Access Compliance Report

Public Rights-of-Way

Intersection ID: 25147	Main Street: CARMEL_ESTATES_RD	Cross Street: REA_RD	Location: SW
ADA ID: D27511F1D80E	Ramp Type: PerpDiag	Initial Pass/Fail: Fail	Overall Compliance: No
		Severity Score: 12.5

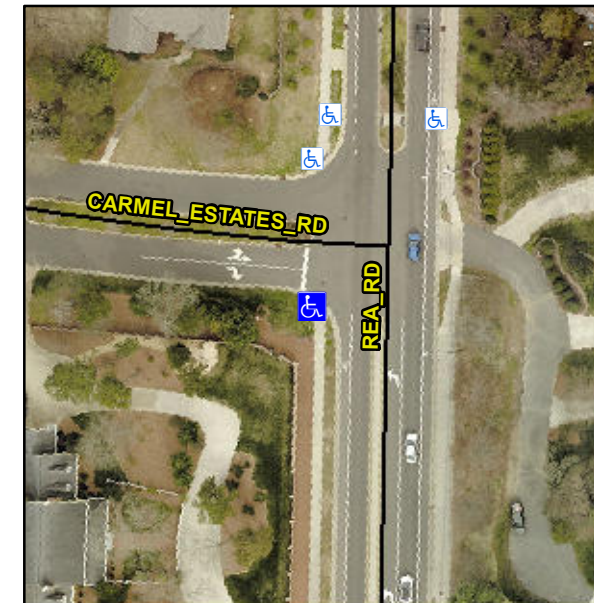
Not Found, R304.2.2

Compliance	Description	Data	Compliance	Description	Data
N/A	Ramp Length (in)	70.0	No	Ramp Slope (%)	9.0
Yes	Ramp Width (in)	89.0	Yes	Ramp XSlope (%)	1.4
N/A	Flare Type LT	N/A	N/A	Flare Type RT	N/A
N/A	Flare Slope LT (%)	N/A	N/A	Flare Slope RT (%)	N/A
N/A	Flare Traversable LT?	N/A	N/A	Flare Traversable RT?	N/A
N/A	Landing Length (in)	N/A	N/A	DWS Provided?	N/A
N/A	Landing Width (in)	N/A	N/A	DWS Contrast?	N/A
N/A	Landing Slope (%)	N/A	N/A	DWS Length (in)	N/A
N/A	Landing X Slope (%)	N/A	N/A	DWS Full Width?	N/A
N/A	Landing Curb? (Y/N)	N/A	N/A	DWS Offset (in)	N/A
N/A	Shared Landing?	N/A			
N/A	Gutter Ponding?	N/A	N/A	Gutter Slope (%)	N/A
N/A	Gutter Lip Ht (in)	N/A	N/A	Gutter X Slope (%)	N/A
N/A	Painted X Walk1?	No	N/A	Painted X Walk2?	No
	X Walk 1 Direction	To E		X Walk 2 Direction	To N
N/A	X Walk 1 Width (in)	N/A	N/A	X Walk 2 Width (in)	N/A
	X Walk 1 Slope (%)	1.4		X Walk 2 Slope (%)	2.7
	X Walk 1 X Slope (%)	2.5		X Walk 2 X Slope (%)	1.7

Remove & Replace Curb Ramp With Two New Directional Ramps or Equivalent.
